Wiltshire Council Planning Consultation Response

Janice Gooch
Senior Conservation Officer
Wiltshire Council Conservation (Central)

Application No: PL/2026/02976 & PL/2026/02719
Creation of new door opening, construction of external staircase and installation of new window opening in rear gable wall, change to hard landscaping and car park surfacing.
The Wheatsheaf Inn, Chilton Foliat, Hungerford, RG17 0TE

Approved Staircase (PL/202303563)

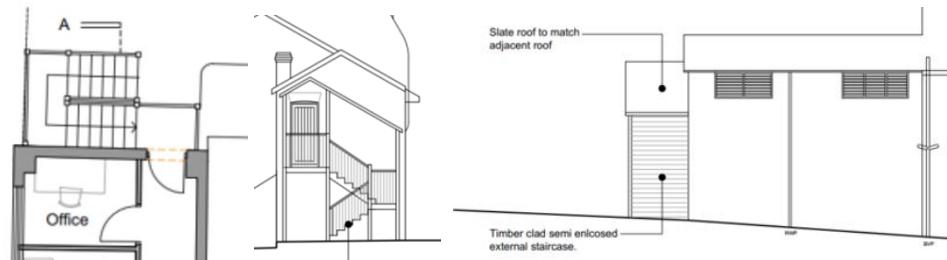
The first approved staircase did not create a balcony or roof and followed a traditional form that is common on outbuildings of a single flight and landing that sat flush with the building. A later application looked to alter and adjust the design, and consent was granted for a small, pitched roof to the staircase which allow access to the staff facilities to the first floor. This retained an open appearance of the treads, reducing the appearance of bulk, and did not create a space that would encourage loitering or seating which would

Approved conversion (PL/2023/03985)

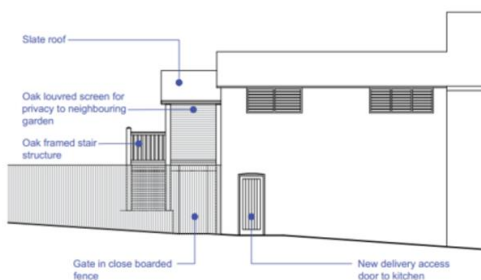
The constructed staircase creates a balcony with an extended roof form, which is not a typical detail found on outbuildings. This staircase has been fully enclosed with timber cladding creating a bulky appearance, with complexity of the structure contrasting with the former gable elevation, increasing the dominance of the structure within the garden and the public realm.

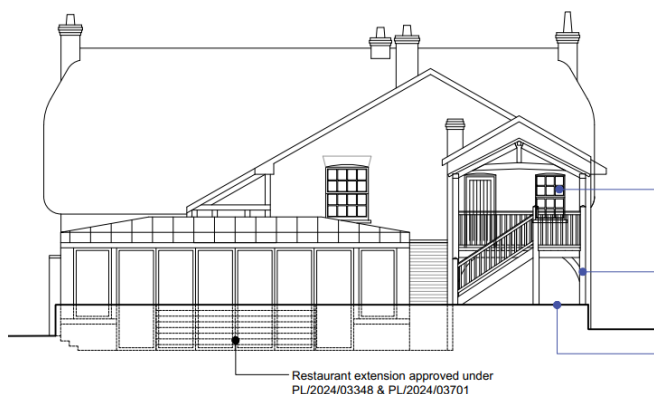
The proposed scheme (drawing) looks to create additional screening to prevent overlooking to the neighbour by infilling the side elevation. This is considered to add to the bulkiness of the addition that is already in existence. As previously noted, the original staircase would not encourage loitering and seating, and therefore there would be limited requirement to add in privacy measures.

Approved site plan (PL/2024/03348)

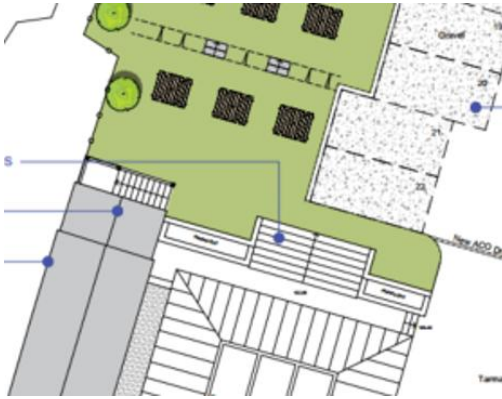
The patio outside of the Orangery has been altered to create a stepped planting either side of the steps. This is different from the proposed plan which forms part of this submission which shows less hardstanding and planting and an increase in the grass area. The proposed scheme offers a softer appearance than the more formal, urban form of formal planters (as built). The proposed drawing of the garden offers a balanced approach between creating an attractive and useable beer garden and the change of levels. The current

Site visit photographs

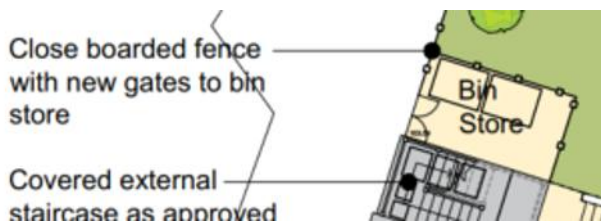
The introduction of the dwarf walls and hedging create a visual separation within the open courtyard, disconnecting the buildings. Whilst some separation is understandable to allow the garden to be enjoyed without views of the car park or creating a safe space for families, the use of low-level brick walls introduces a more permanent separation of the space, and if some separation was required, the use of an open fence could be considered which has been used at the end of the garden to separate the garden/ seating area and the parking. This fence is open and is not considered to cause harm to the setting of the listed building but allow some separation between garden and parking but is not shown on the proposed plans.

Approved drawings showing fenestration pattern and no lantern to Orangery.

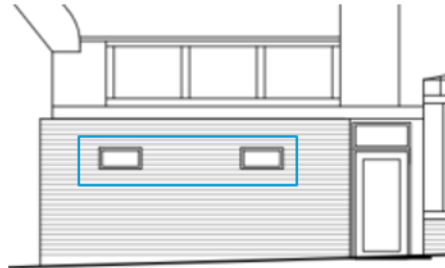
Green = Different fenestration pattern to approved scheme
Purple = Insertion of lantern raising the height of the proposed roof
Orange = Insertion of Extract / MEP to support the use of the kitchen

WC extension with high level windows which add interest and break appearance of elevation

These elements should be regularised via an application or altered to suit the approved scheme.
